**FINAL  
ENVIRONMENTAL IMPACT STATEMENT**

**SUPERCONDUCTING  
SUPER COLLIDER**

**Appendix 5  
Errata**

**December 1988**

Figure 5.5.11-1

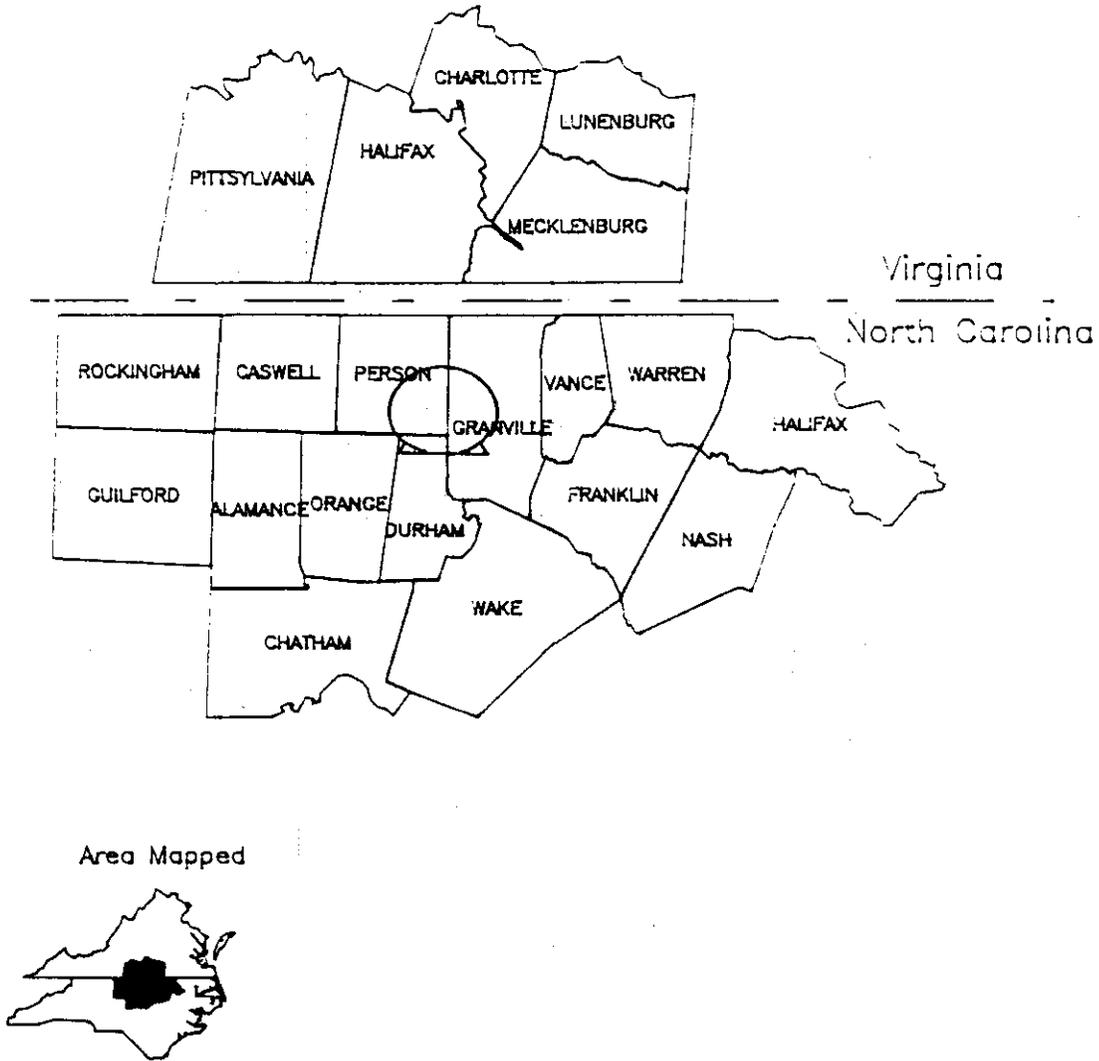
- Page 88:** Figure 5.5.11-1, in the Legend, the units on the distance scale should be labeled as representing feet.
- Page 91:** Par. 1, delete the last sentence and add the following: A land use plan and zoning ordinance are currently under consideration for adoption by Granville County.  
Par. 4, delete Line 9 and add the following: The southwestern portion lies within the planning and zoning jurisdiction of the community of Butner, and is classified as a rural watershed area. The northern and southeastern portions lie within the planning jurisdiction of Granville County and is designated as rural watershed in the land use plan and zoning ordinance presently under consideration.

Figure 5.7.2-1

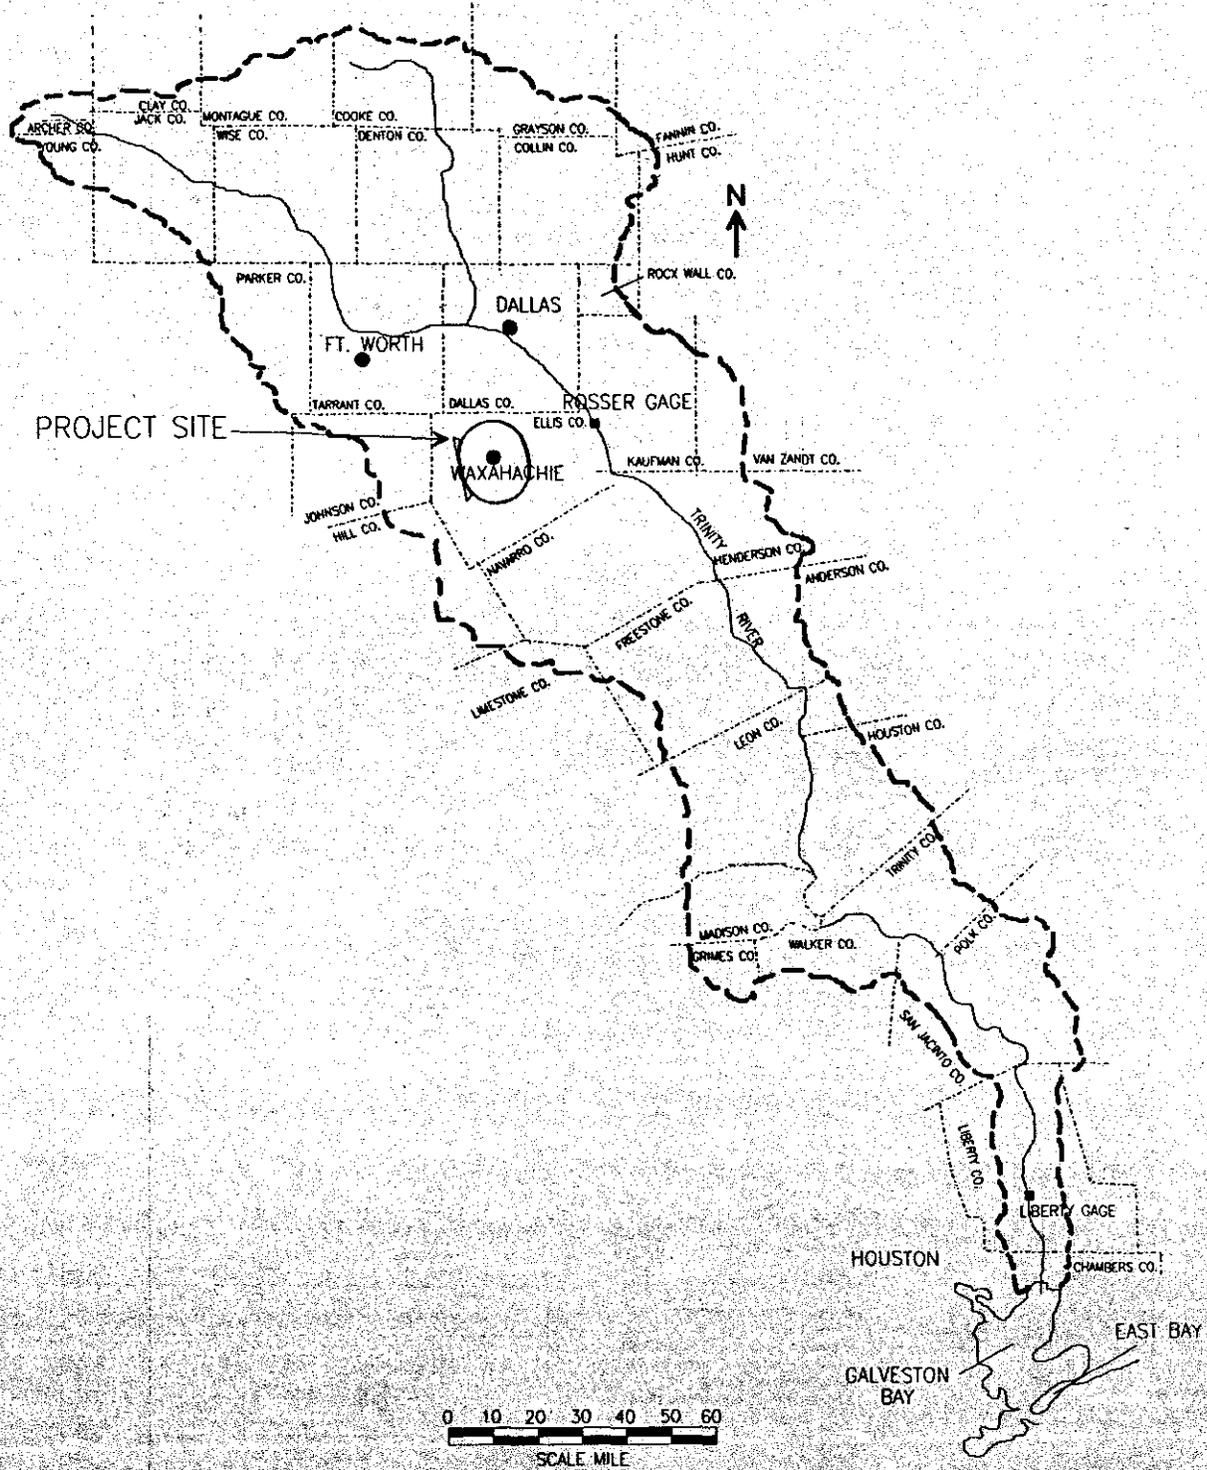
- Page 19: Figure 5.7.2-1, source should read: Trinity River Authority of Texas.
- Page 22: Par. 2, delete the last sentence and insert: The lake is used for recreation and water supply (Texas Water Commission 1986) as well as flood control.  
Par. 3, delete the last sentence and insert: Its drainage area is 30 mi<sup>2</sup>; the reservoir is used primarily for recreation (Texas Water Commission 1986) and water supply (Dowell and Petty 1973).
